# UNITED STATES PATENT AND TRADEMARK OFFICE

10/764,525

Jae-Bon Koo

<b>Office Action Summary</b>	<b>Application No.</b>	<b>Applicant(s)</b>	
	10/764,525	KOO, JAE-BON	
	<b>Examiner</b>	<b>Art Unit</b>	
	SUN M. KIM	2813

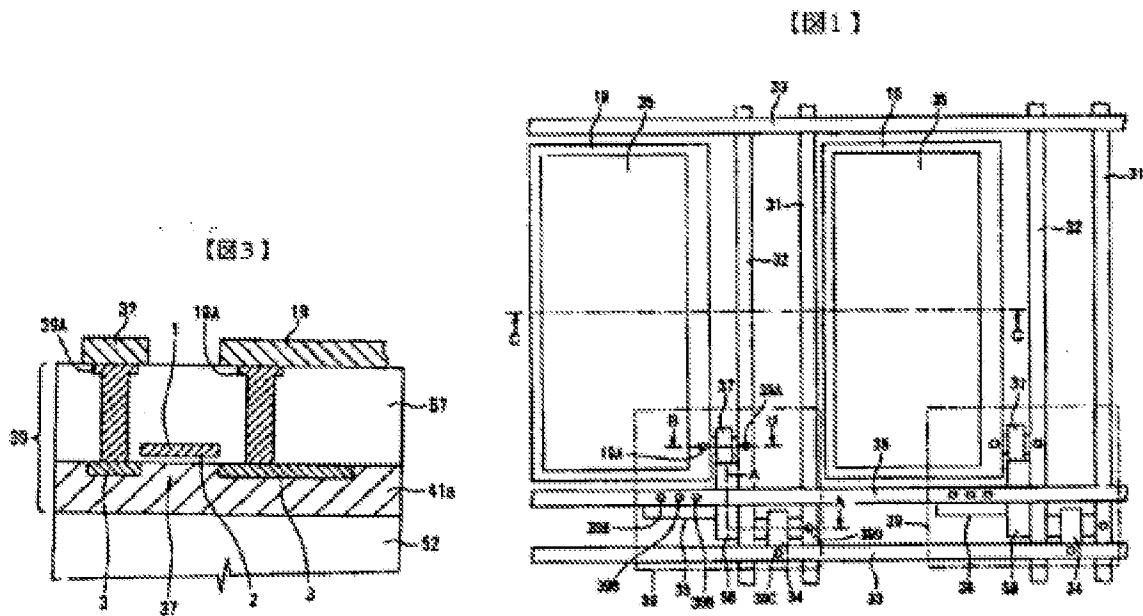
3. **Claims 1, 3, and 10 – 13** are rejected under 35 U.S.C. 102(b) as being anticipated by Nozawa et al. (JP 2003-15548).

4. **In re claim 1**, Nozawa et al. shows a flat panel display, comprising (Figure 3):

- a gate line 33, a data line 31 and a power supply line 32 formed on an insulation substrate 52;
- a pixel region defined by the gate line 33, the data line 31 and the power supply line 32 (also Figure 1);
- and a pixel comprising a pixel electrode 19 arranged in the pixel region, the pixel electrode 19 being formed on the same layer as the power supply line 32, wherein the power supply line 32 is arranged on a layer different from the gate line 33 or the data line 31 (also Figure 1). In the instant case, the power supply line 32 is arranged on a layer different from the gate line 33.

5. **In re claim 3**, Nozawa et al. teaches that the power supply line 32 and pixel electrode 19 both being formed of the same material (Figure 3).
6. **In re claim 6**, Nozawa et al. teaches a flat panel display, comprising (Figure 3):
  - a data line 31 arranged on a same layer as the source and drain electrodes 39A & 19A (for instance, the same layer being substrate 52; also Figure 2 for data line 31);
  - a thin film transistor comprising source and drain electrodes 39A/19A, formed on an insulation substrate 52;
  - an insulation film 57 formed on the insulation substrate 52 and on the thin film transistor, the insulation film 57 being perforated by first and second contact holes exposing the source and drain electrodes 39A/19A respectively;

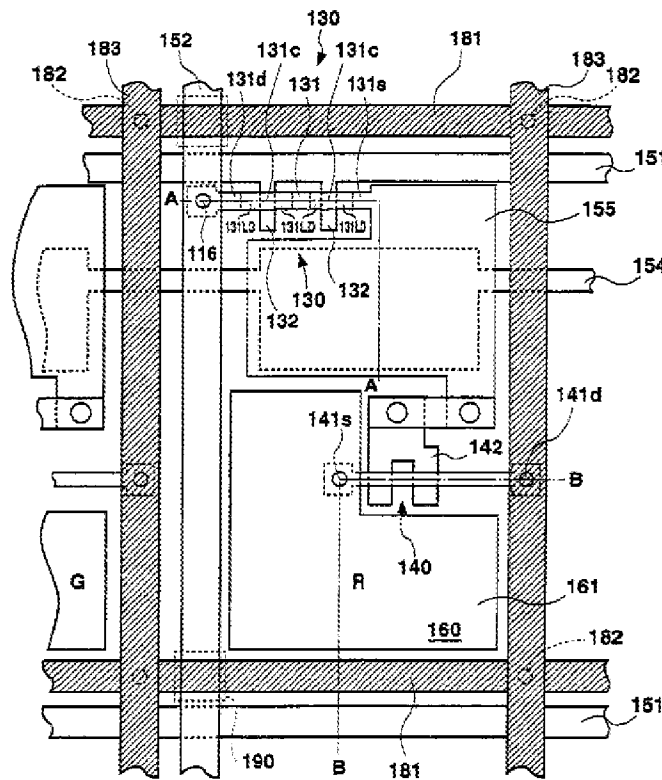
12. **Claims 4 – 5 and 7 – 9** are rejected under 35 U.S.C. 103(a) as being unpatentable over Nozawa et al. in view of Koyama (US PGPub 2003/0117083). Nozawa et al. does not teach that pixel electrode 19 is made from a material meeting the claimed characteristics, however, Koyama et al. teaches that electrode 49 can be gold (Figure 4). It would have been obvious to one having ordinary skill in the art at the time of the invention to use gold for a pixel electrode since doing so would allow for one to make a top emitting device such as shown by Koyama. Also, Nozawa et al. teaches that power supply line 32 is made from a conductive material such as metal (Paragraph 61). Koyama et al. teaches that gold is a conductive metal. It would have been obvious to one having ordinary skill in the art at the time of the invention to use gold for the power supply line of Nozawa et al. since Nozawa et al. suggests using a conductive metal and it is well known that gold is a very good conductor.

13. **In re claims 4 and 5**, the above combination would teach that both the pixel electrode and power supply line be made of gold. Gold has low resistivity and high reflectivity.

14. **In re claims 7 - 8**, the above combination would teach that both the power supply layer and pixel electrode being formed of gold. Gold has a low resistivity and a high reflectivity.

15. **In re claim 9**, the above combination teaches that the pixel electrode and the power supply layer being formed of gold. The feature of "being formed of a single film of a material" is a product by process feature. It has been held that "[E]ven though product-by-process claims are limited by and defined by the process, determination of
